UNITED STATES PATENT AND TRADEMARK OFFICE

Office Action Summary	Application No. 10/565,426	Applicant(s) HALLAM, DAVID RICHARD	
	Examiner BRYAN D. RIPA	Art Unit 1795

DETAILED ACTION

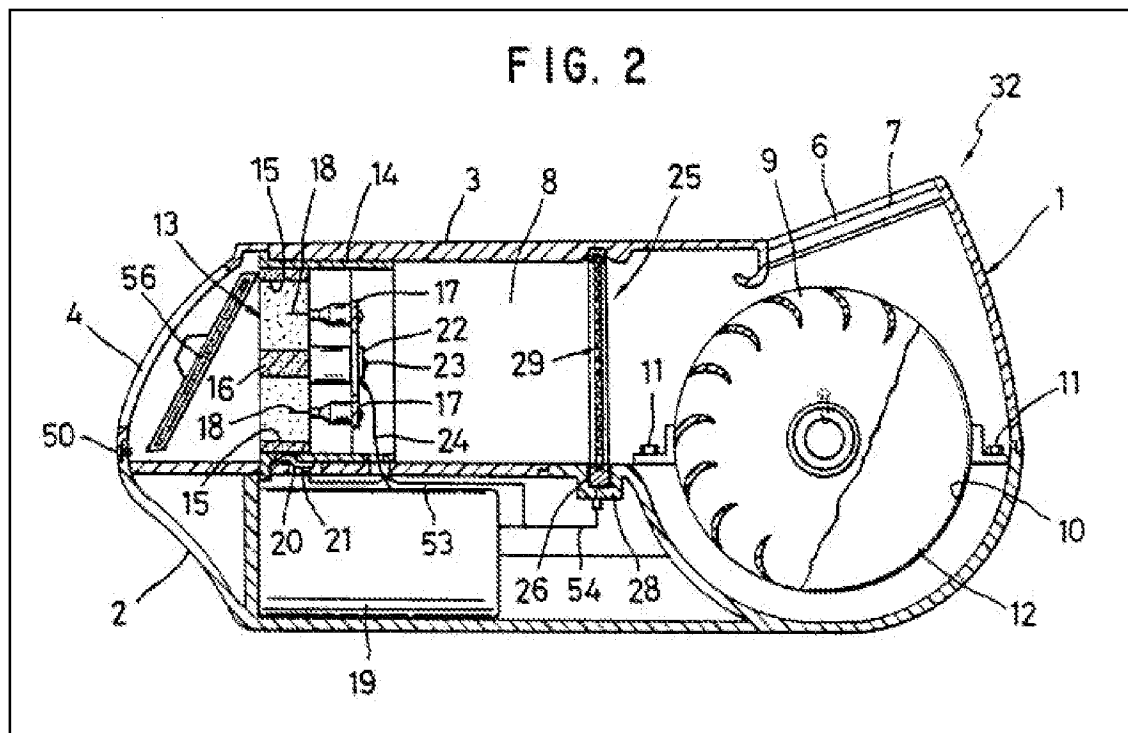
Regarding claim 1, YIKAI teaches an apparatus for the treatment of air comprising a low power corona discharge ozone generator (see col. 1 lines 6-11 discussing the device being an air cleaner employing the use of a corona discharge which generates ozone which would aid in the purification and cleansing of the air moving through the device) mounted inside a chamber having an air inlet and an air outlet (see air inlet 4 and air outlet 6) and at least one air flow impeller formed and arranged for inducing a flow of air through said chamber (see fan 9; col. 3 lines 66-67 teaching the fans purpose to drive air through the device), said ozone generator being formed and arranged for generating a restricted concentration of ozone and any other reactive species formed together therewith, within an inactivating zone contained within said chamber, through which said air flow is passed in use of said apparatus (see col. 3 lines 1-9 discussing the use of a high voltage corona discharge, which would generate ozone, within the space occupied by electric precipitating device 13 up to carbon filter 29, i.e. an inactivating zone, through which the air flow is passed), which restricted concentration is sufficient effectively to inactivate airborne pollutant material entrained in said air flow (see col. 3 lines 1-9; col. 3 lines 27-30 teaching the generation of ozone by the high voltage corona discharge), yet which restricted concentration decays sufficiently outside said inactivating zone so that the concentration of ozone in the cleaned air expelled from said apparatus is at a physiologically acceptable level without the use of an ozone decomposition catalyzer (see carbon filter 29; col. 4 lines 15-24 teaching the use of a carbon filter outside the inactivating zone to reduce the ozone

concentration by chemical reaction so as to emit air from the device free of ozone). See figure 2 below.

Regarding claim 2, YIKAI teaches the apparatus for the treatment of air wherein said low power corona discharge ozone generator comprises a low power corona discharge device provided with a low power high voltage output transformer (see voltage impressing apparatus 19; col. 3 lines 5-8). See figure 2 above.

Regarding claim 7, YIKAI teaches the apparatus for the treatment of air wherein the inlet is fitted with at least one filter (see filter 56; col. 3 lines 55-58). See figure 2 above.

Regarding claim 8, YIKAI teaches the apparatus for the treatment of air wherein is provided at least one filter for removing tobacco smoke (see col. 4 lines 7-14 teaching the collection of tobacco smoke on collecting electrode 16, i.e. electric precipitating apparatus 13 acting as a filter). See figure 2 above.

Regarding claim 9, YIKAI teaches the apparatus for the treatment of air wherein the outlet is fitted with at least one filter (see fins 7; col. 2 lines 46-48 stating air outlet 6 having a number of fins which would act as a filter). See figure 2 above.

Regarding claim 17, YIKAI teaches a method of cleaning air without the use of an ozone decomposition catalyzer (see discussion above with respect to claim 1 discussing the use of a carbon filter to chemically react with the ozone), comprising the steps of: providing an apparatus of claim 1 (see the discussion above with respect to claim 1), powering the ozone generator of said apparatus so as to generate ozone in

the inactivation zone of said apparatus (see col. 3 lines 59-63; col. 3 lines 5-8 and col. 3 lines 27-30), and operating said airflow impeller so as to pass a flow of said air through said inactivation zone (see col. 3 lines 64-68). See figure 2 above.

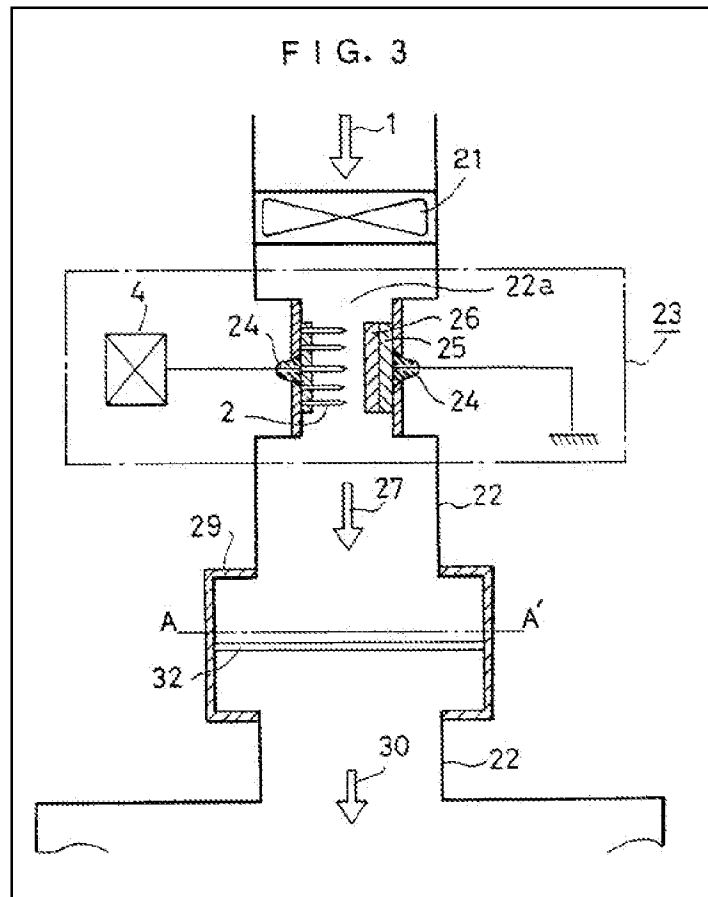
Regarding claim 1, IKEDA teaches an apparatus for the treatment of air comprising a low power corona discharge ozone generator (see ionization chamber 23; col. 10 line 66-col. 11 line 9 describing the apparatus used for creating the corona discharge; col. 11 lines 15-17 teaching the formation of ozone) mounted inside a chamber having an air inlet and an air outlet (see air inlet and outlet at the top and bottom of figure 3) and at least one air flow impeller formed and arranged for inducing a flow of air through said chamber (see fan 21; col. 10 lines 32-34), said ozone generator being formed and arranged for generating a restricted concentration of ozone and any other reactive species formed together therewith, within an inactivating zone contained within said chamber, through which said air flow is passed in use of said apparatus (see col. 11 lines 10-17 discussing the use of a high voltage corona discharge to generate ozone, within the space occupied by ionization chamber 23 up to heating resistor 32, i.e. an inactivating zone, through which the air flow is passed), which restricted concentration is sufficient effectively to inactivate airborne pollutant material entrained in said air flow (see col. 11 lines 10-17 discussing the use of a high voltage corona

discharge to generate ozone), yet which restricted concentration decays sufficiently outside said inactivating zone so that the concentration of ozone in the cleaned air expelled from said apparatus is at a physiologically acceptable level without the use of an ozone decomposition catalyzer (see col. 13 lines 54-59 discussing embodiment 3, as shown in figure 3, not requiring the presence of ozone decomposition catalysts but instead using heat to decompose the residual ozone). See figure 3 below.

Regarding claim 2, IKEDA teaches the apparatus for the treatment of air wherein said low power corona discharge ozone generator comprises a low power corona discharge device provided with a low power high voltage output transformer (see high voltage generator 4; col. 1 lines 19-22 and col. 11 lines 5-6 discussing the application of a several kV potential by the voltage generator). See figure 3 above.

Regarding claim 16, IKEDA teaches the apparatus for the treatment of air wherein the low power corona discharge device has a solid dielectric (see dielectric 26; col. 10 lines 39-42). See figure 3 above.

Regarding claim 17, IKEDA teaches a method of cleaning air without the use of an ozone decomposition catalyzer (see discussion above with respect to the rejection of claim 1 under IKEDA discussing the use of a pyrolytic means to decompose the ozone), comprising the steps of: providing an apparatus of claim 1 (see the discussion above with respect to the rejection of claim 1 under IKEDA), powering the ozone generator of said apparatus so as to generate ozone in the inactivation zone of said apparatus (see high voltage generator 4), and operating said airflow impeller so as to pass a flow of said air through said inactivation zone (see col. 10 line 63-col. 11 line 17). See figure 3 above.
